Ref: 1219

PLAN CHANGE 61 – Request for Further Information

Thank you for your letter dated 6 September 2019 requesting further information for Plan Change 61 at the corner of Creyke Road and State Highway 73, Darfield. The information requested has been addressed as follows:

Revision C

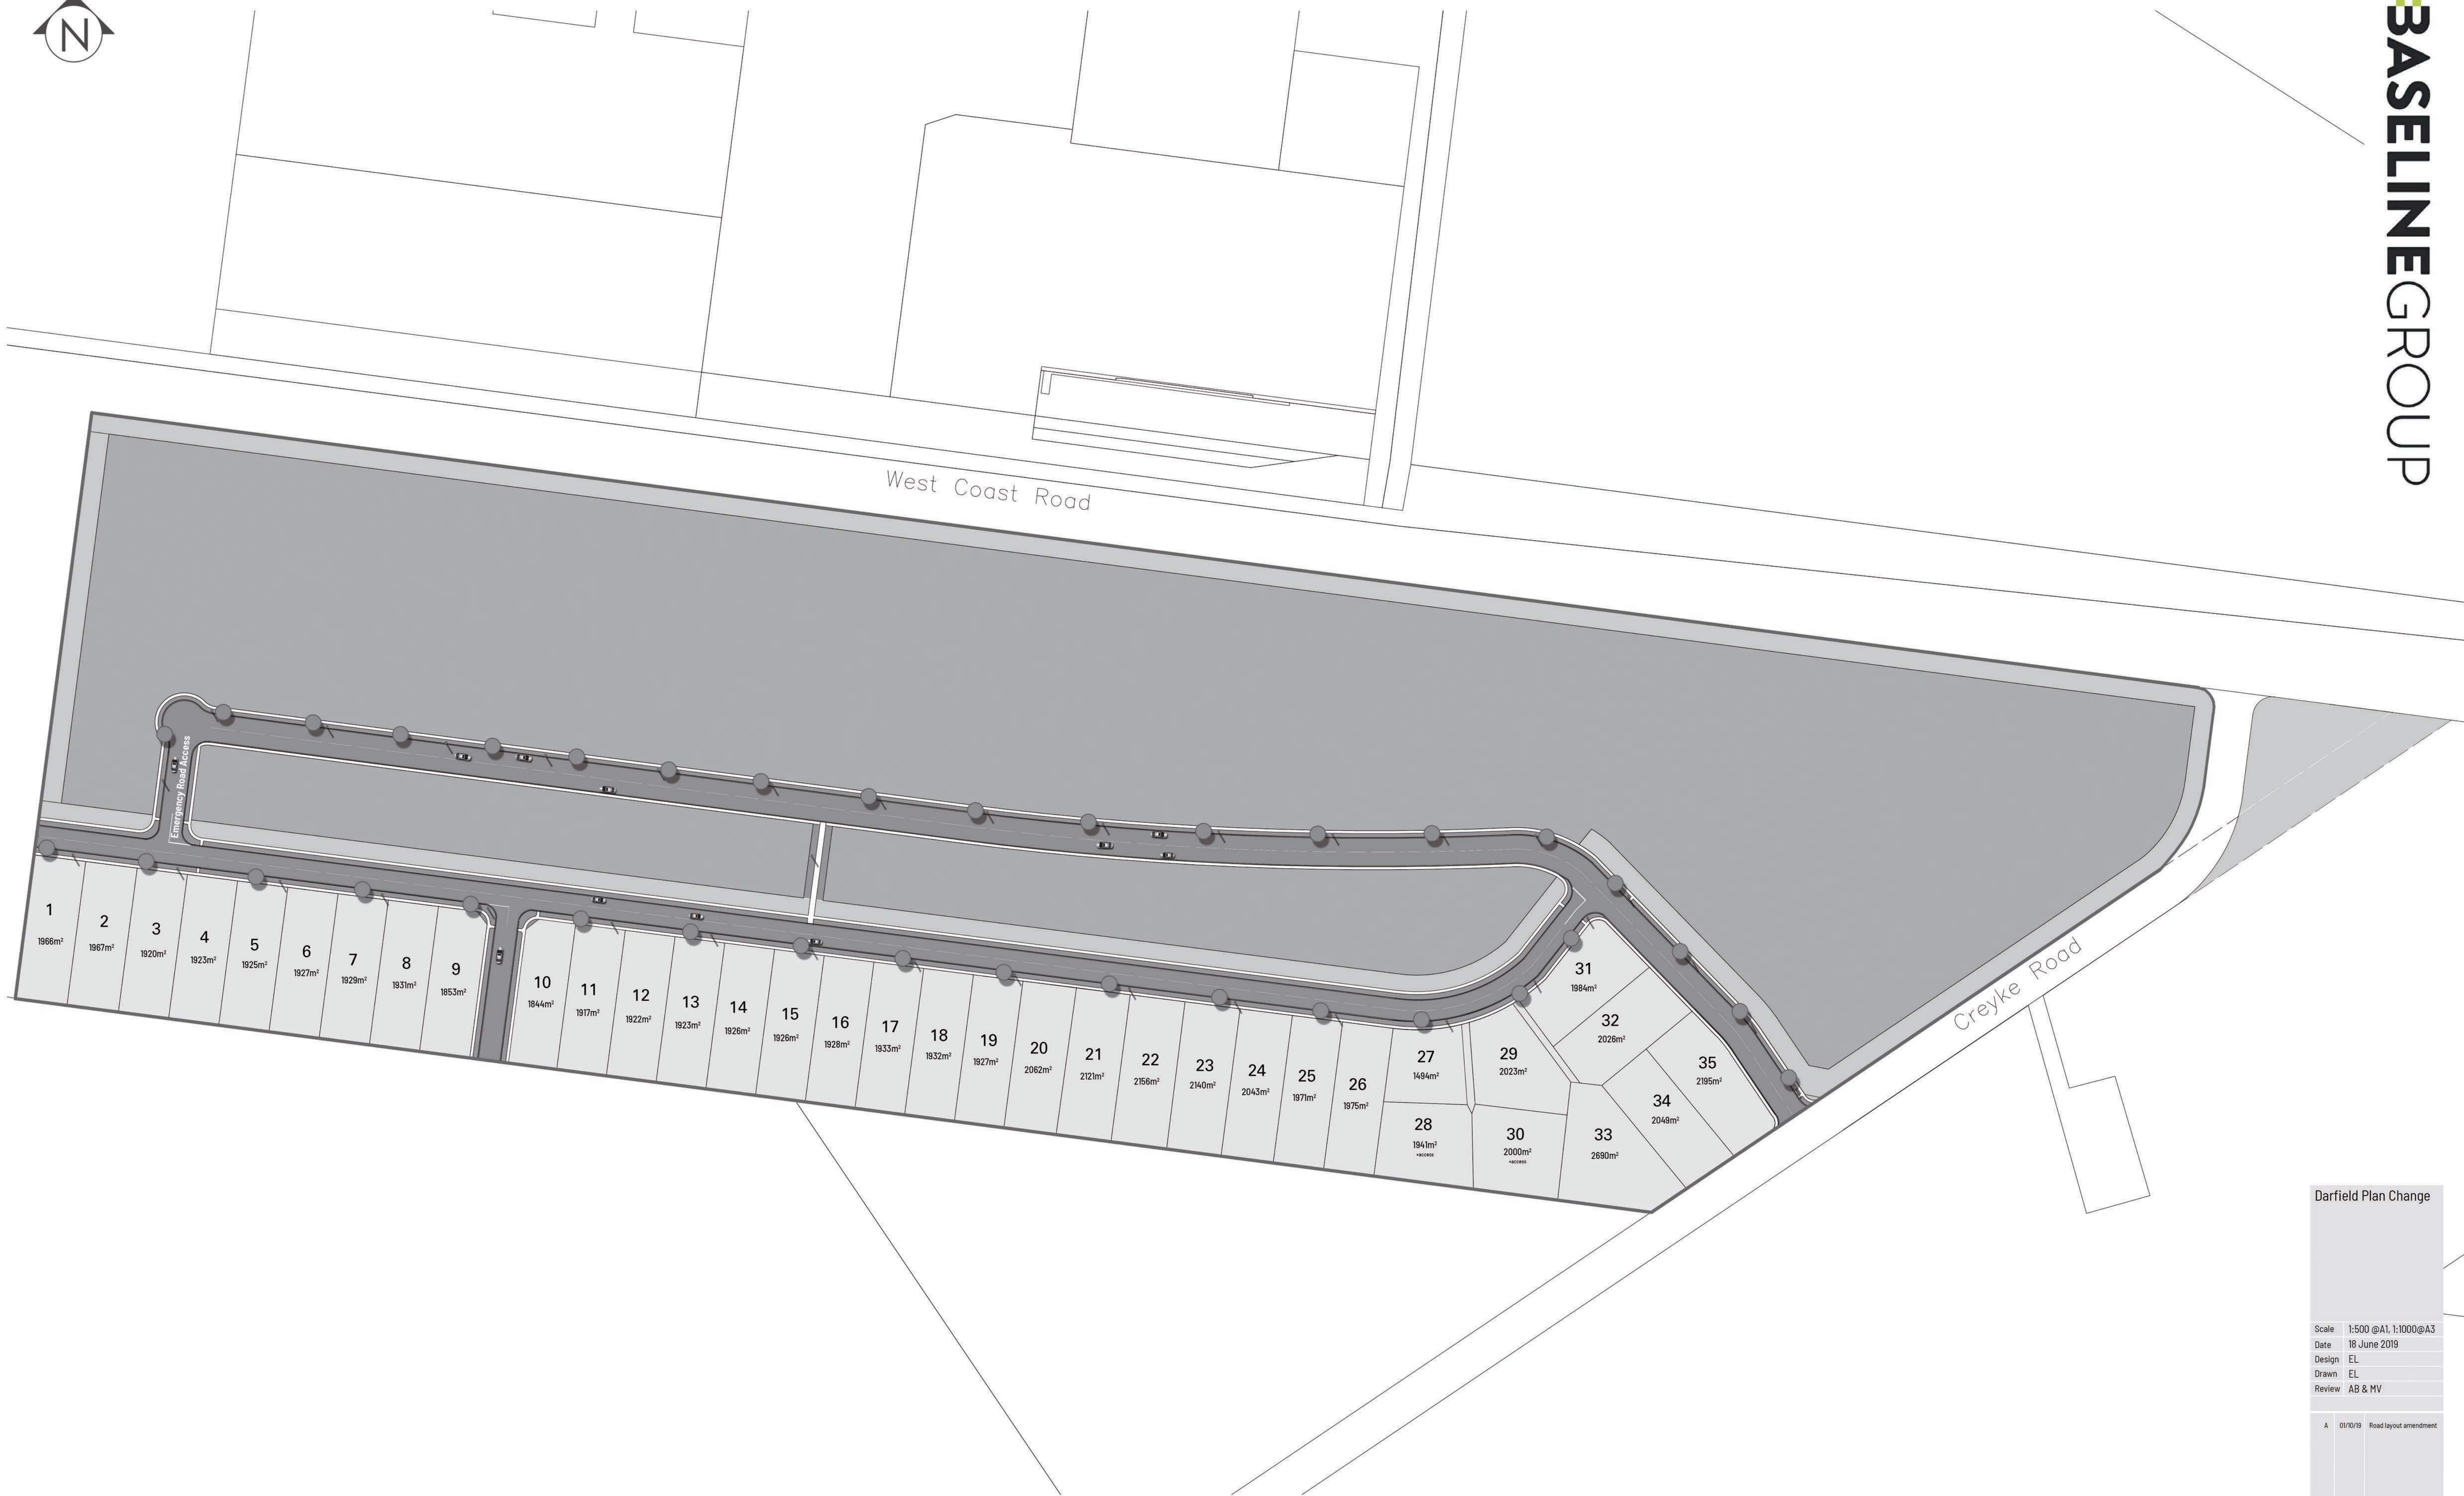
3. Can you provide alternative road layout that takes into account the operative plan's restriction on cul-de-sacs of 150m in length, as outlined in appendix 1. This is to provide for safety in emergencies and better access through the development.

- 1. The cul-de-sac at the end of the proposed road servicing the business road will need to be a minimum 30m head diameter.*
- 2. The business road is an overly long no exit road. Having that degree of traffic generation only accessible to the wider roading network at one point is inadvisable, providing no resilience if an access is blocked (e.g. in an emergency).*
- 3. The length of the cul-de-sac's are restricted to 150m in length.*
- 4. The road for the living zone seems overly narrow. The provisions would require it to be formed and vested as a minimum 6m wide carriageway.*

5. *The road for the living zone, whilst indicating continuing through to the adjacent site, should provide for a turn-around space until that road is continued.*

It is considered undesirable to encourage commercial scale vehicles (i.e. truck and trailer units) to utilise the primary residential road. Therefore, the amended ODP attached indicates an emergency lane that discourages regular use by vehicles through traffic calming devices such as chicanes but still provides alternative access to the Cul-de-sac during emergencies.

In considering these points it should be noted there is sufficient space to accommodate a 30 m diameter turning head within the proposed cul-de-sac as shown on the attached amended plans, and the final details of the roading layout are more appropriately dealt with as part of any future subdivision. An alternative emergency access has been provided on the ODP however, it is not desirable to have commercial vehicles entering or exiting past residential dwellings where possible.

A resource consent to enable a longer cul-de-sac will be required at the time of subdivision should the emergency access not be included.

The Living zone road can meet current roading standards for a living zone, and the width of the carriageway would need to be determined as part of the subdivision consent application. The amended roading cross sections attached show that compliance with current roading standards including a 6m wide carriageway can be achieved within the legal road widths provided. The proposal includes an overall through road to land to the west. Any temporary turning head on this road will need to be managed through the subdivision stage, rather than indicated on an ODP.

Sheet 8

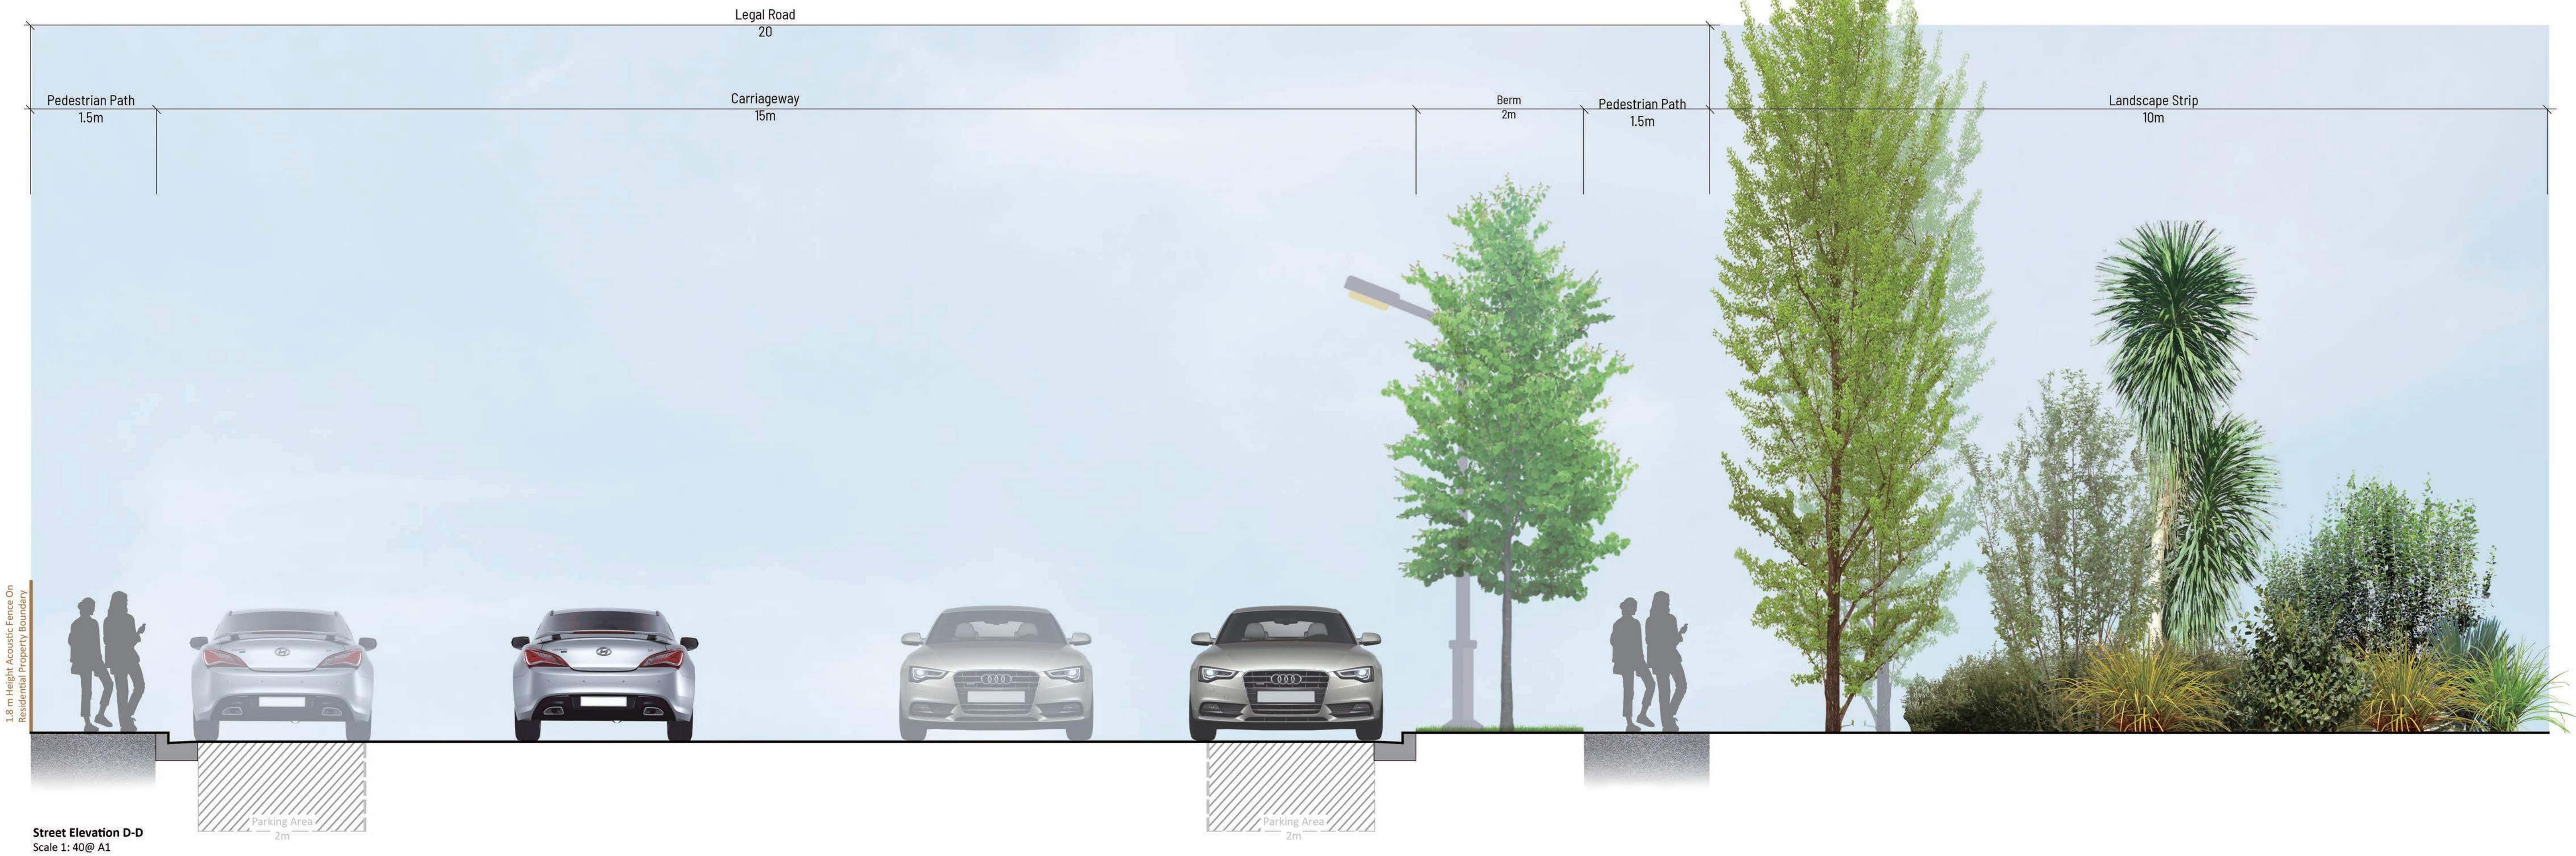
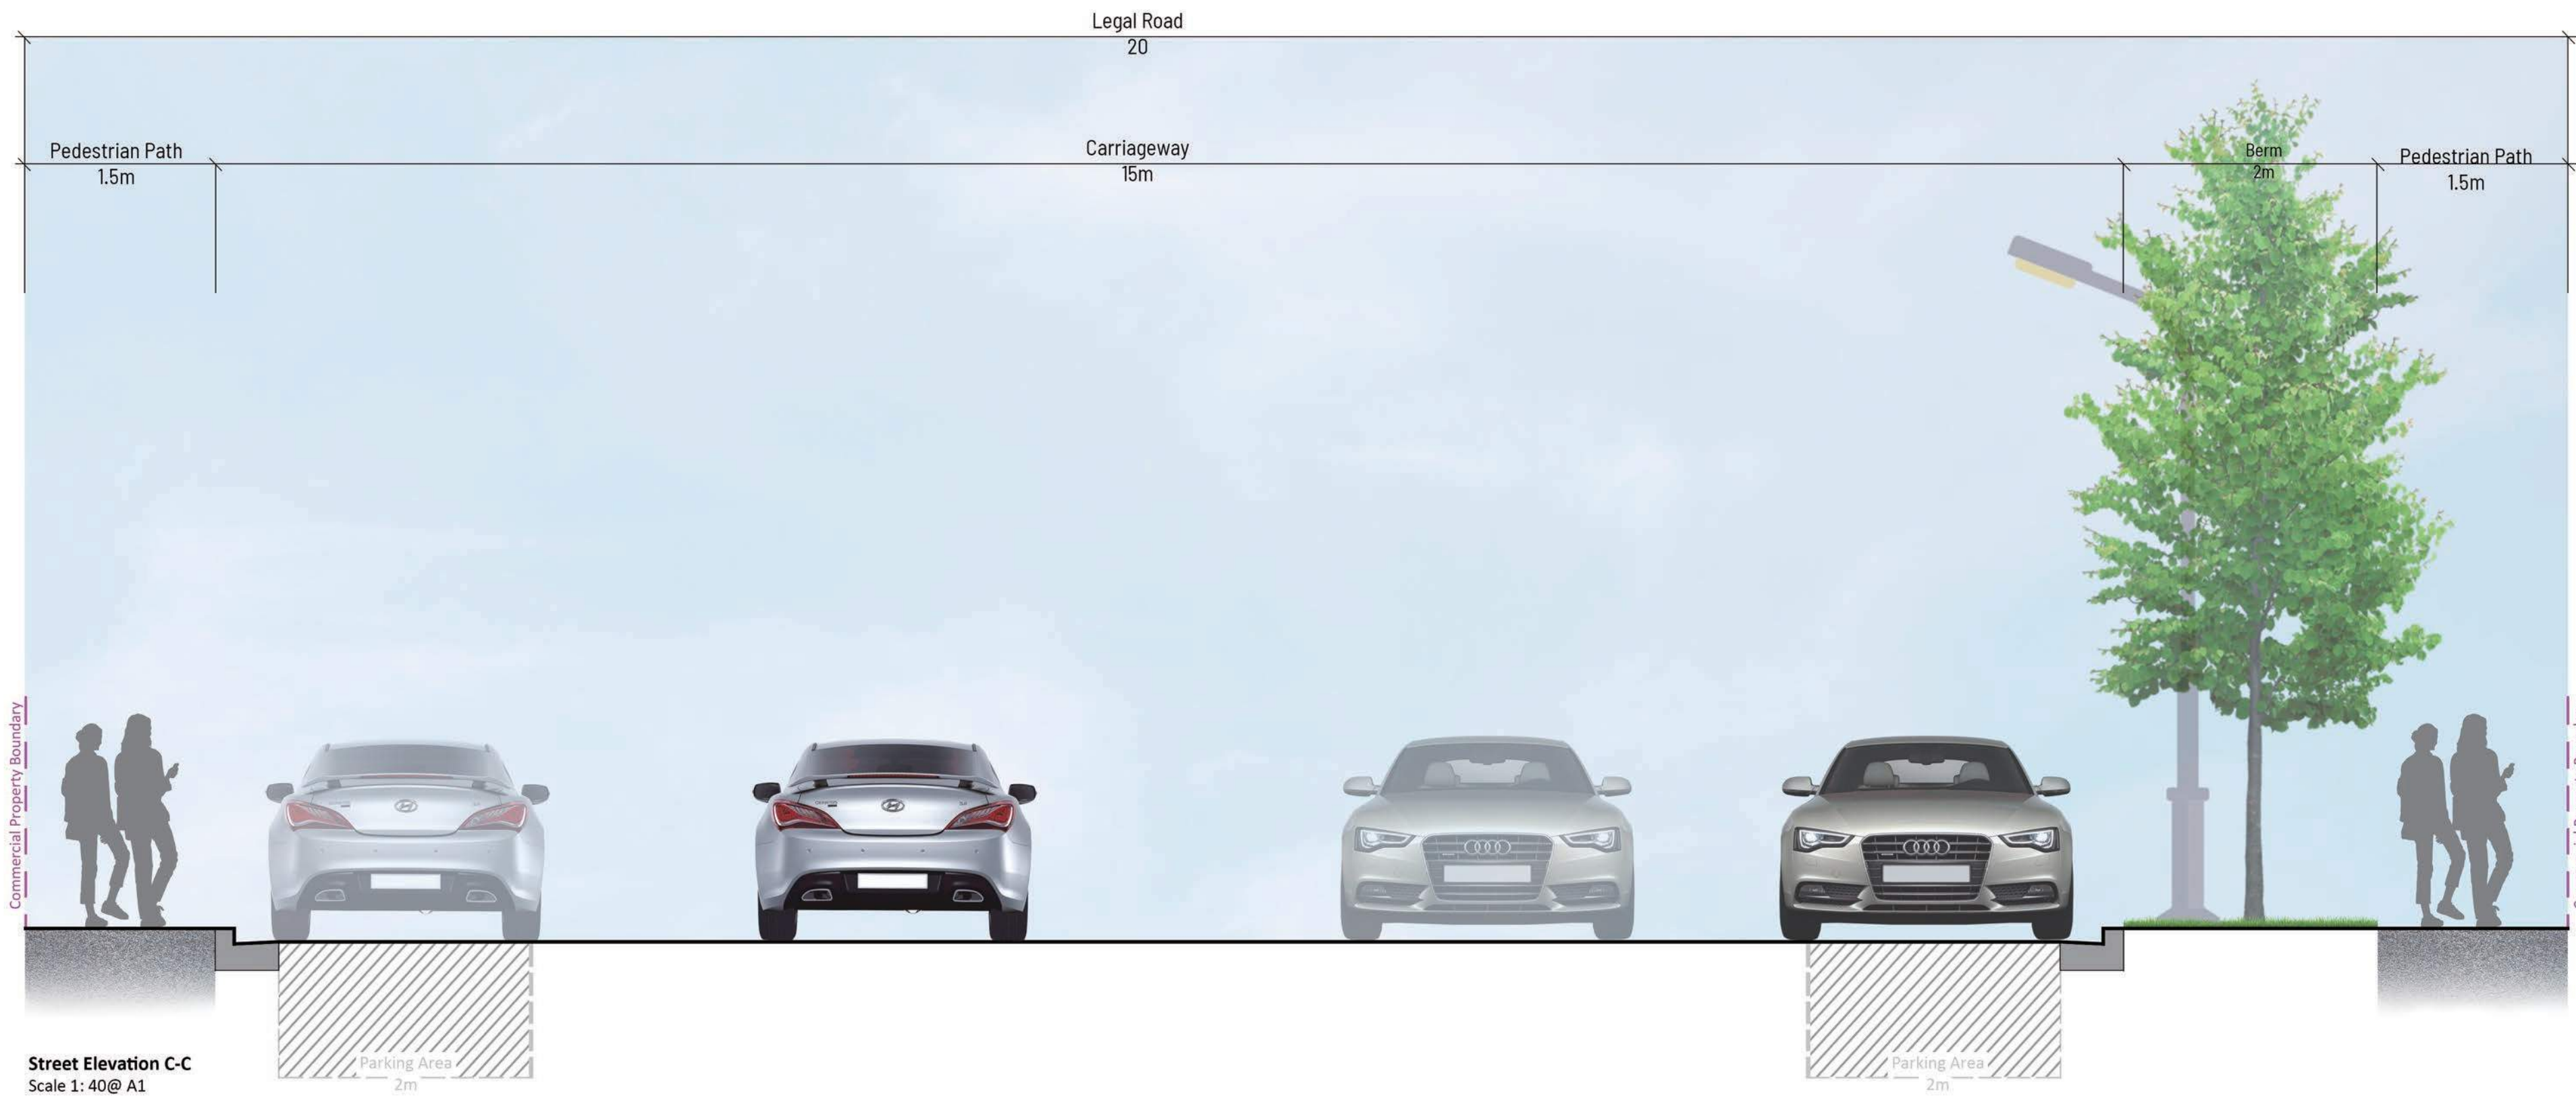
2. Can you provide further information showing some indicative road and access cross-sections, which can help us understand the basis for the road layout and the level of service being provided to cater for the generated traffic.

The cross sections of the roading layouts in Appendix 12 of the application have been updated to show compliant roading layouts within the various areas indicated on the ODP. These are attached and demonstrate that sufficient width has been provided in the proposed roading layout to meet the requirements of the Selwyn District Plan, however final design of the roading layout is more appropriately accommodated at subdivision and development stage when the actual needs of the roading network are better understood.
